**Re: Vectren Energy Delivery of Ohio, Inc.
OPSB Case No. 13-1651-GA-BTX**

Re: Vectren Z-167 Relocation @ Dayton International Airport: Mill Creek Floodplain
Floodplain Development Permit **2014-01**

Z-167 Pipeline
Montgomery County, Ohio
Exhibit "A"

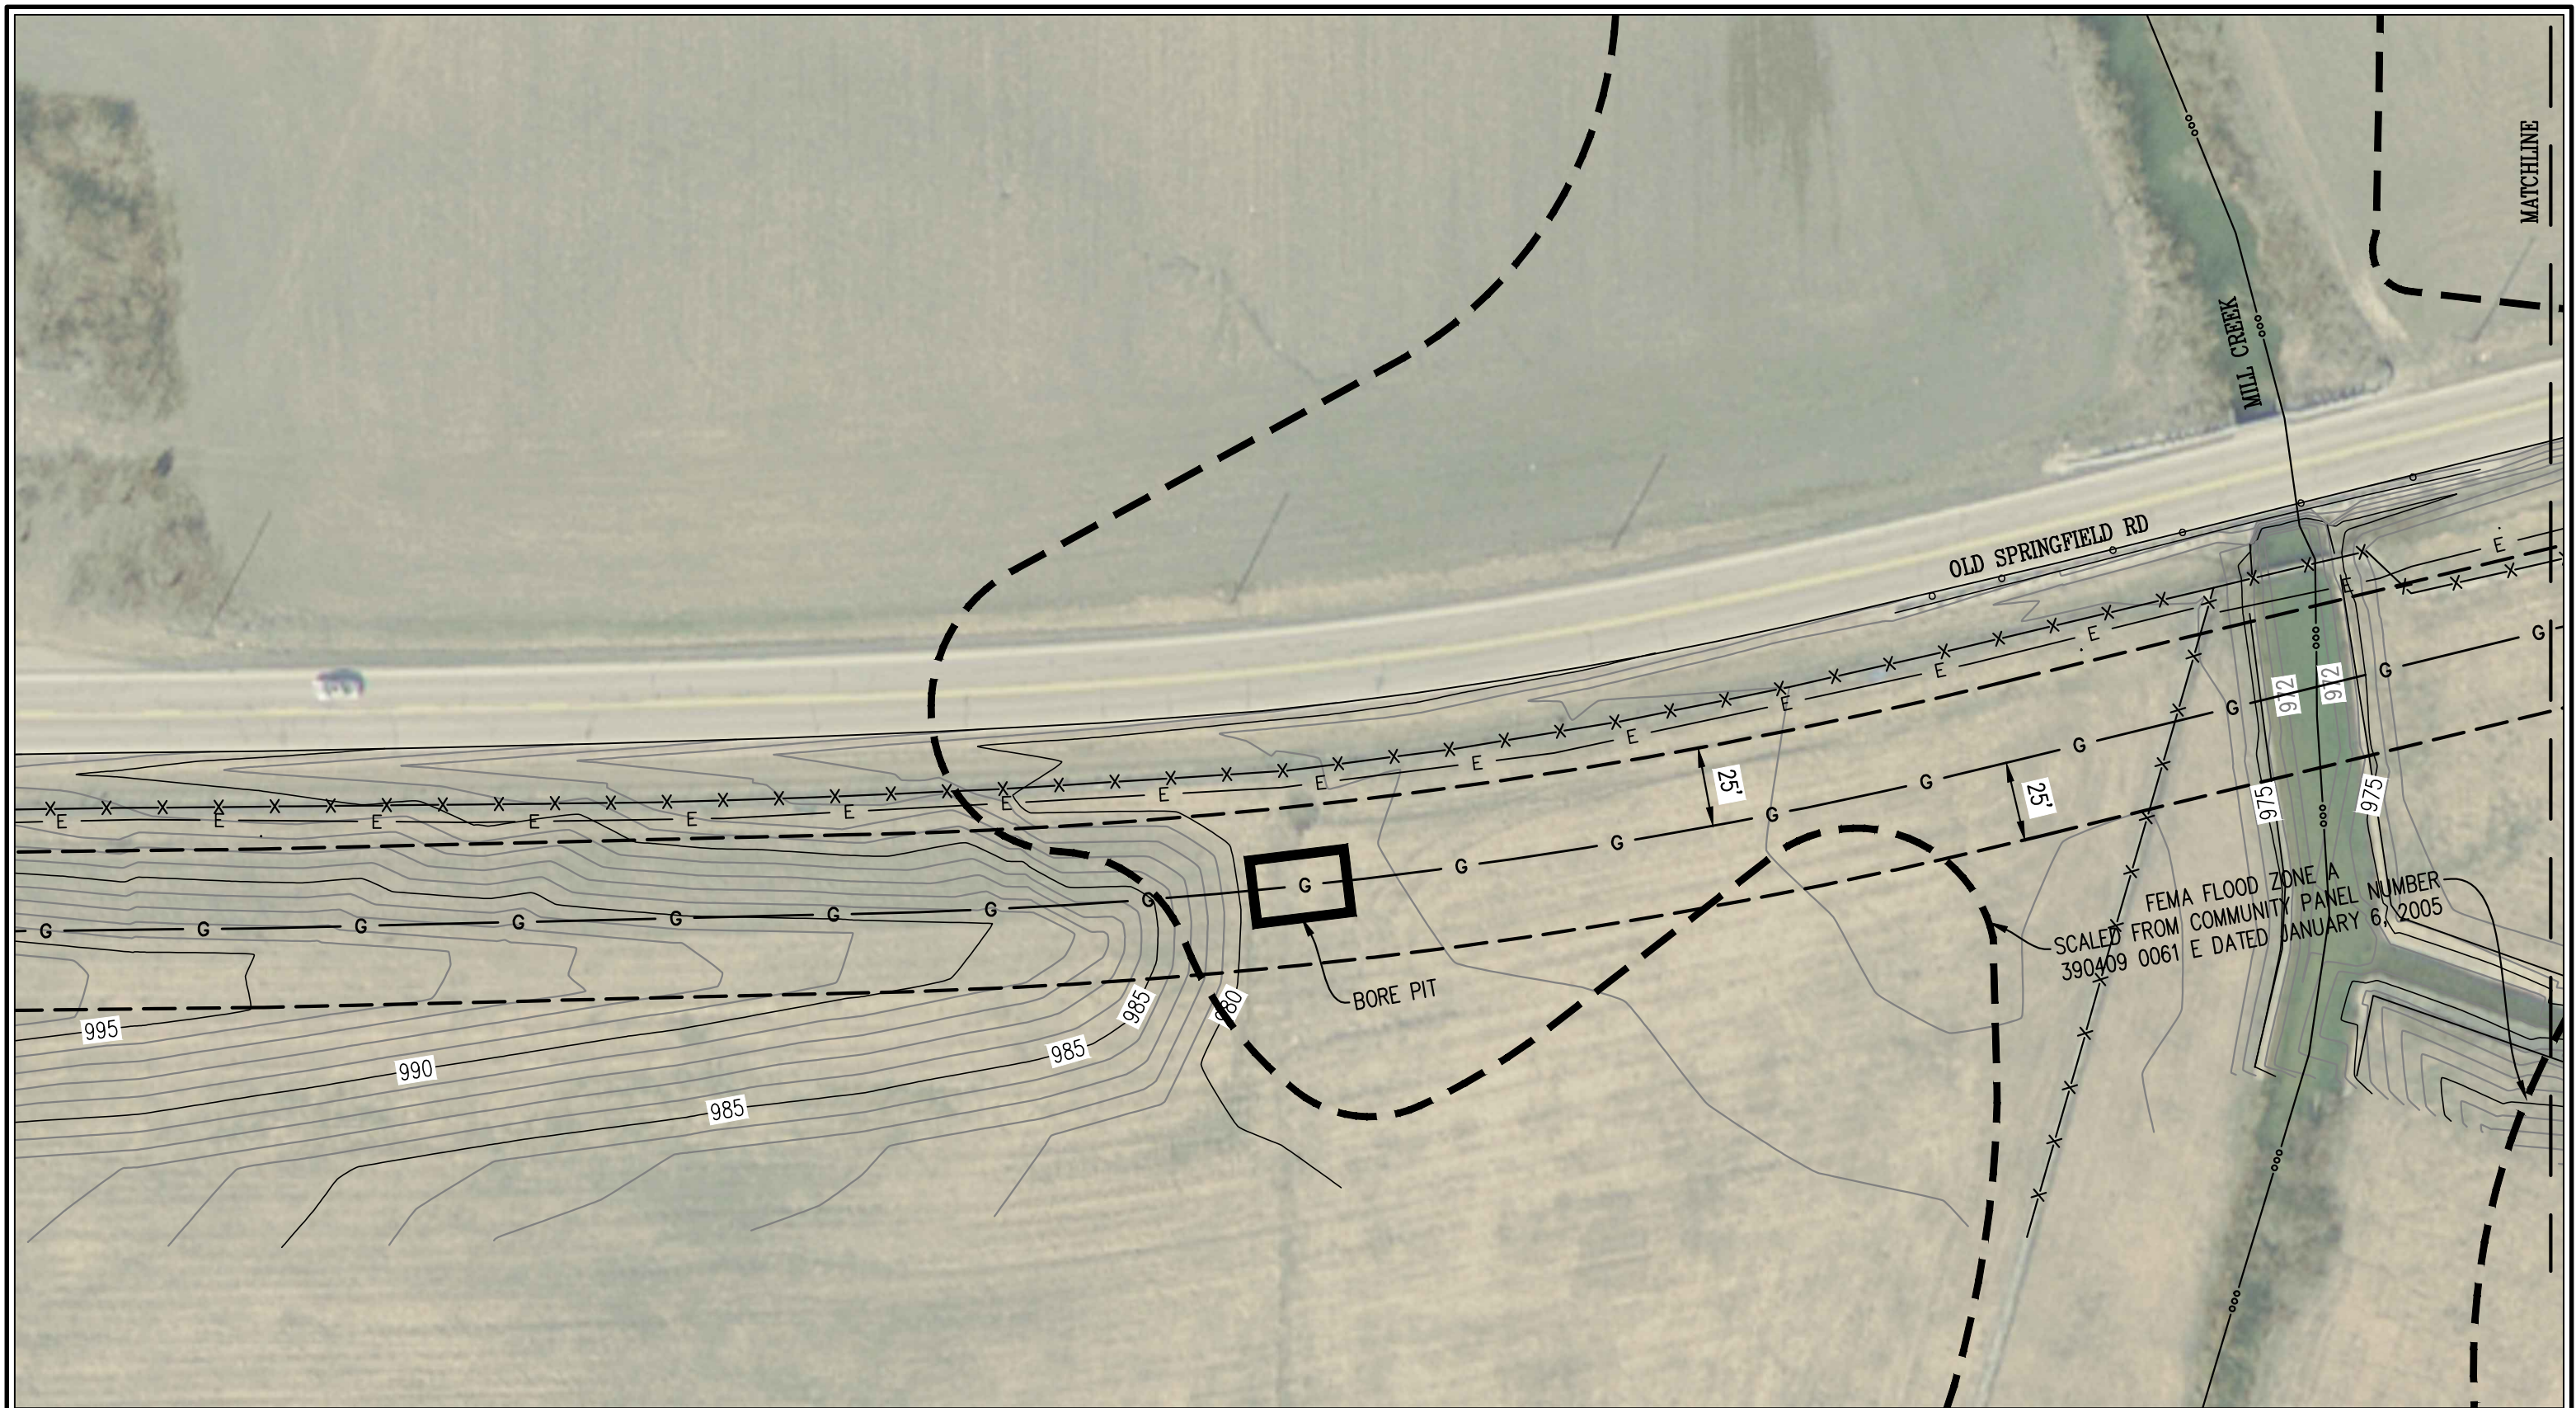
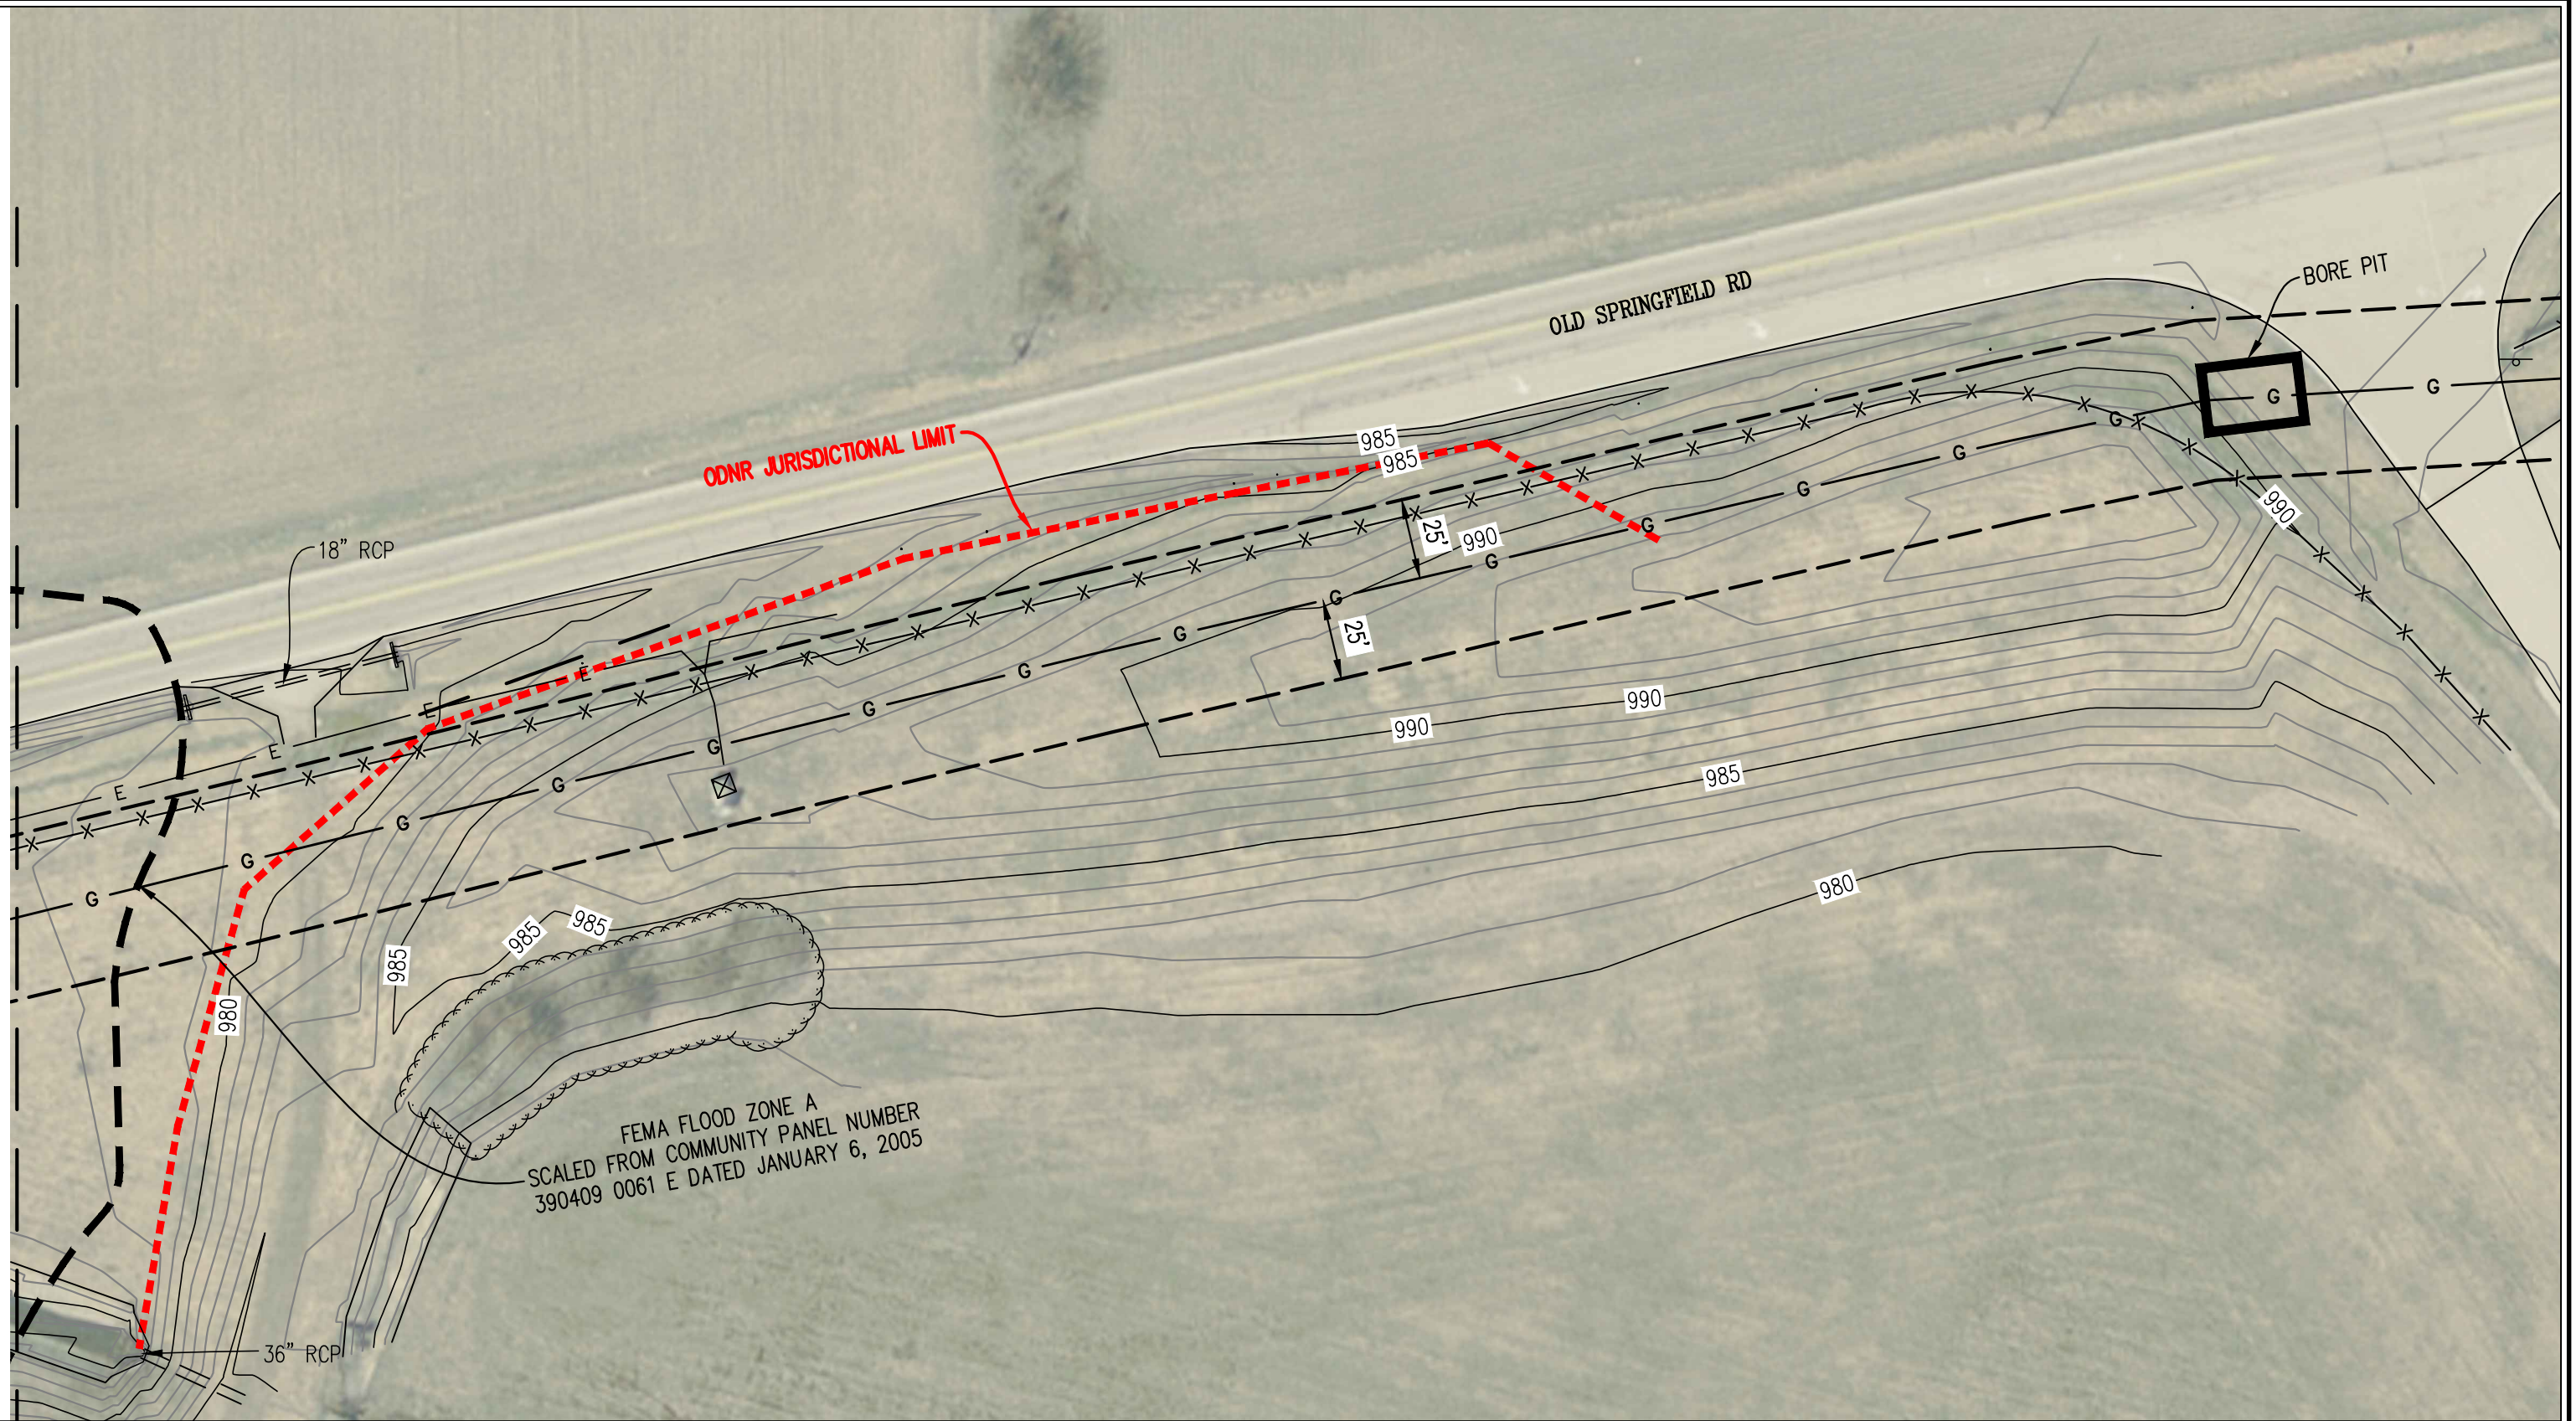
I have been reviewing your information and I have a question. Would you describe the functioning of the bore pits; specifically how long are they intended to be in place; will there be any permanent structure left at the bore pit? Thanks for your help

Typically the bore pits are only open for a week, the estimated time required to directionally drill the pipe and tie it in with the rest of the pipeline. The minimum depth of the pipeline below the surface is four feet and will be a minimum of five feet below the bed of Mill Creek. There will be no permanent structures above the surface, other than the required pipeline safety markers at intersections, stream crossings and other locations as needed. These markers are roughly 4" wide by 36" tall, some of which will be test stations for monitoring the cathodic protection on the pipeline.
